National Committee on Uniform Traffic Control Devices

NCUTCD Proposal for Changes to the Manual on Uniform Traffic Control Devices

TECHNICAL COMMITTEE: Regulatory and Warning Signs Committee
ITEM NUMBER: 19A-RW-02
TOPIC: HILL BLOCKS VIEW Sign
ORIGIN OF REQUEST: RWSTC Discussions
Task Force: Dan Paddick (Chair) Randy McCourt, Herman Hill, Dan Waddle, James Sullivan, Jeff Wolfe, Jim Pline
AFFECTED SECTIONS OF MUTCD: Section 2C.18, Figure 2C-4 and Figure 2C-12

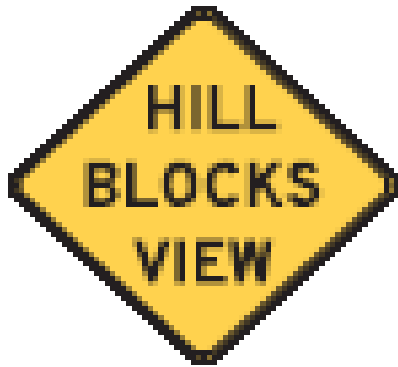
Delete W 7-6 from Figure 2C-4

267 Add to Figure 2C-4

01a A Limited View (WX-Y) sign (see Figure 2C-4) may be used on the approach to a crest vertical curve where stopping sight distance is limited advising road users that their view is obstructed.

01b A Limited View sign may be supplemented by a LIMITED VIEW (W13-ZP) plaque.
